Docket No. 50-346

License No. NPF-3

Serial No. 731

- I. Change to Davis-Besse Nuclear Power Station Unit 1, Appendix A Technical Specifications 3.4.2, 3.4.3, 4.4.3 and bases concerning the setpoint index for pressurizer electromatic relief and code safety valve.
 - A. Time required to Implement
This change is to be effective upon NRC approval
 - B. Reason for Change (Facility Change Request 79-348)
To reduce the probability of opening pressurizer electromatic relief and code safety valve during a transient
 - C. Safety Evaluation
See attached

FIGURE 1.

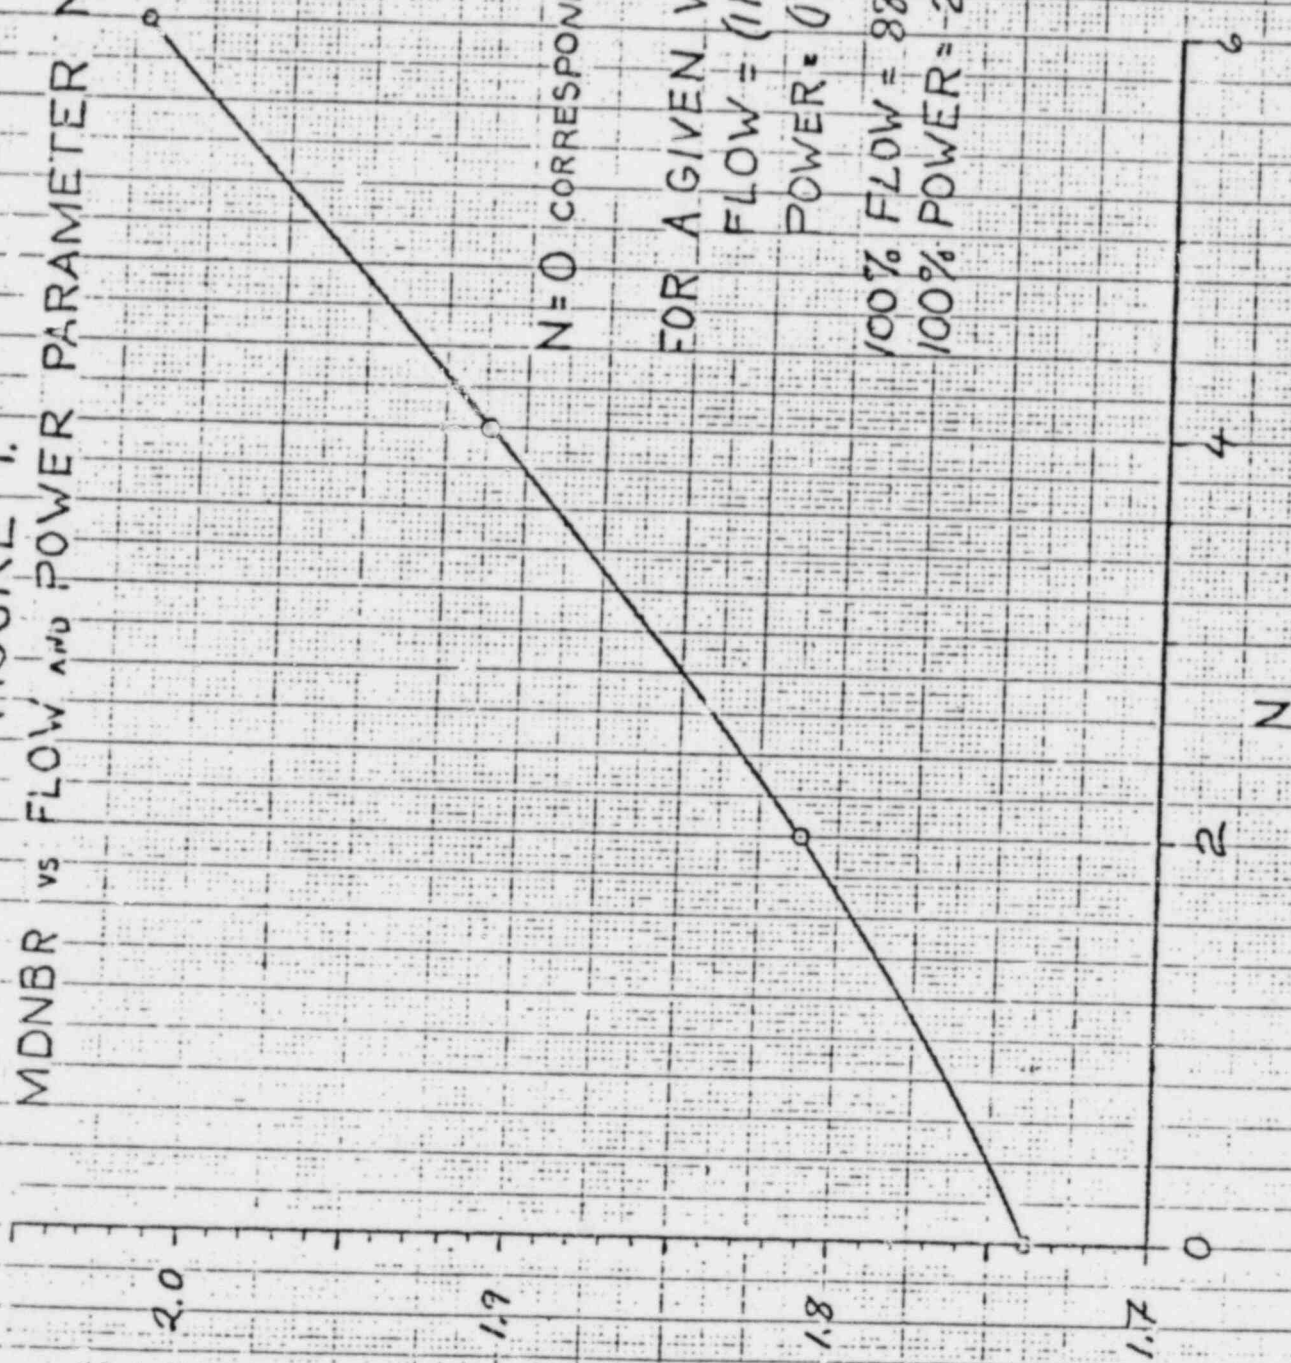
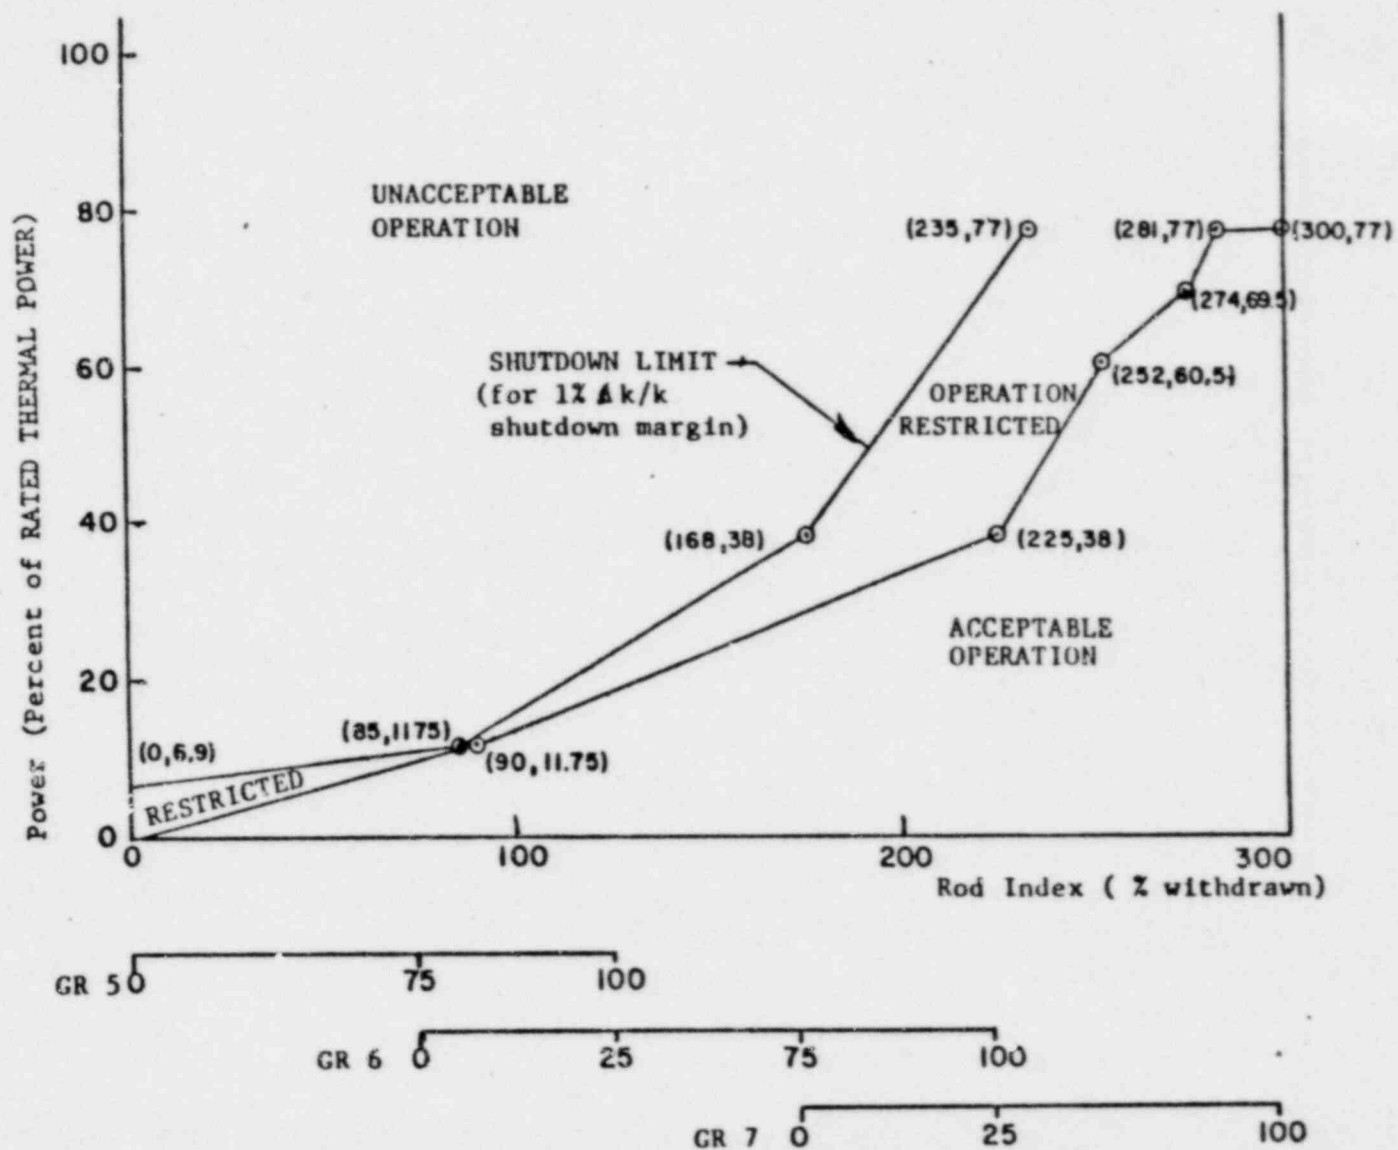
As noted above, this license amendment request also modifies the action statement for Technical Specification 3.2.5. This specification sets limits on the DNB related parameters of reactor coolant pressure, flow and hot leg temperature. According to the present Technical Specifications, if any of these parameters falls outside the prescribed limits, the parameter is required to be brought within limits within two hours or thermal power reduced to less than 5% of rated thermal power within the next four hours.

The safety function achieved by this Technical Specification is to ensure that DNB limits are not violated. The present Technical Specification action statement requirement is too restrictive for reactor coolant flow. The measured system flow at Davis-Besse is 111.4% of

88,000 gpm/reactor coolant pump (after taking into account the 2.5% measurement uncertainty) whereas Technical Specification 3.2.5 calls for 110% flow. This license amendment request proposes that for every 1% flow that is below the limit, thermal power be reduced by 2% of rated thermal power. B&W has performed calculations to determine the DNBR margin gain for the proposed flow and power tradeoff. The CHATA and TEMP codes were used to determine hot bundle flow, and subchannel flow and minimum DNBR, respectively. A factor N was defined as the percentage reduction in thermal power. The design overpower case of 112% of 2772 MWt and 110% of design reactor coolant system flow was used as the basis for comparison. An increase in DNBR margin was observed when power was decreased per the proposed change when flow was off-limit. Figure 1 provides a graph of this increase in DNB margin. B&W has also concluded that this analysis is bounding for the case of three reactor coolant pumps operating and adequate DNB margin will also be gained in that case if the modified action statement is followed. Based on the above, it is concluded that by following the revised action statement, adequate margin to DNB is gained thereby enhancing the safety function achieved by this Technical Specification. In addition, it further reduces the possibility of an undesired unit shutdown and increases unit availability.

1. Restore the parameter to within its limit within 2 hours, or
2. Limit THERMAL POWER at least 2% below RATED THERMAL POWER for each 1% parameter c is outside its limit for four pump operation within the next 4 hours, or limit THERMAL POWER at least 2% below 75% of RATED THERMAL POWER for each 1% parameter c is outside its limit for 3 pump operation within the next 4 hours.

DAVIS-BESSE NUCLEAR POWER STATION
UNIT NO. 1
OFF SITE ORGANIZATION CHART
FIGURE 6.2-1

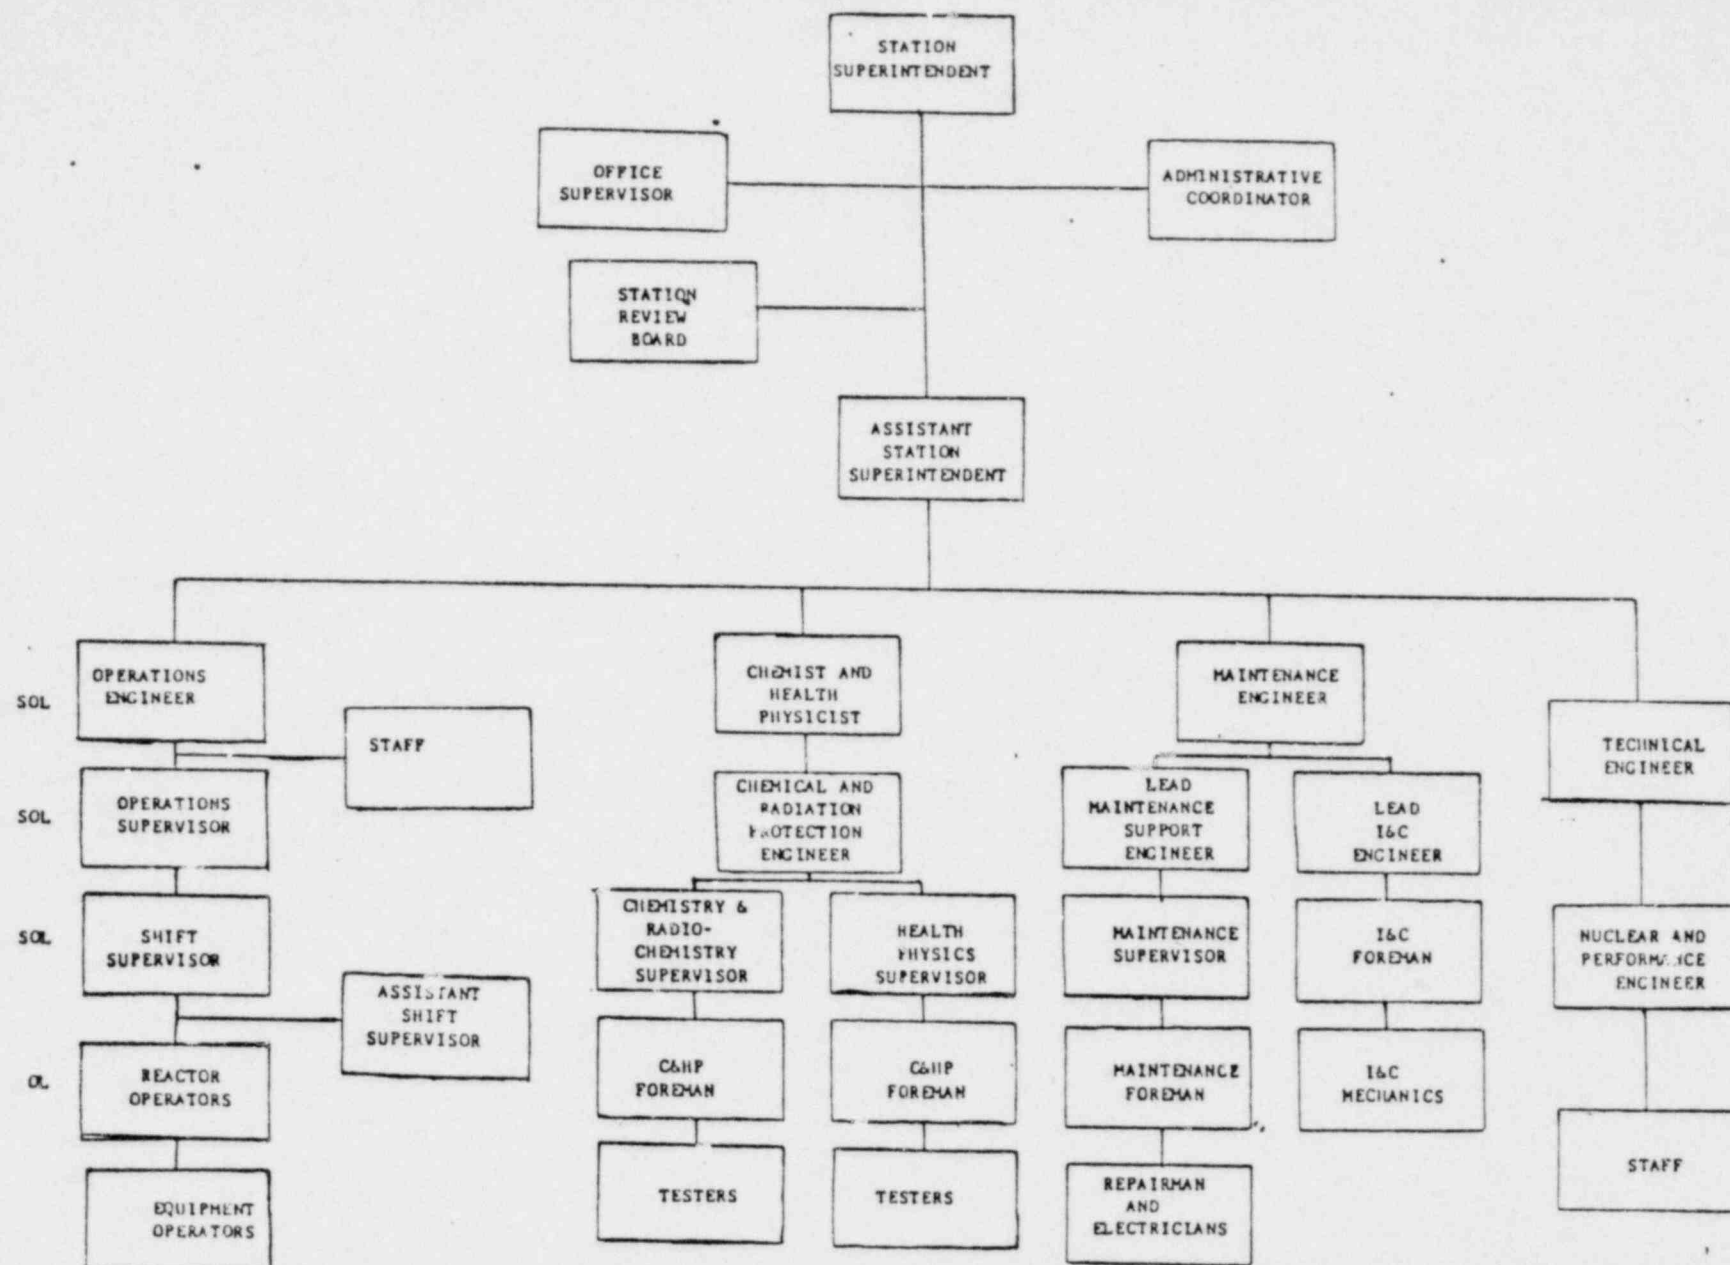
- I. Change to Davis-Besse Nuclear Power Station Unit 1, Appendix A
Technical Specifications 6.5.2.2, Figures 6.2-1 and 6.2-2 concerning
CNRB membership and organizational changes.
 - A. Time required to Implement
This change is to be effective upon NRC approval
 - B. Reason for Change (Facility Change Request 80-249C, D) To
reflect organizational changes at Toledo Edison
 - C. Safety Evaluation
See attached

The organizational changes to the CNRB will only change some members and not the function of the board. The changes improve independence and expertise on the board in facilitating their function.

The safety function of the station organization is to show lines of responsibility for overall facility operation and maintenance of the station in a safe, reliable and efficient manner. The operating license requirement has been deleted from the Assistant Shift Supervisor. This position is an administrative function to aid the Shift Supervisor. The number of licenses in the crew composition is governed under Section 6, Table 6.2-1. Any license required functions by the control room organization shall be dispatched in accordance with 10 CFR 50.54 and Part 55.
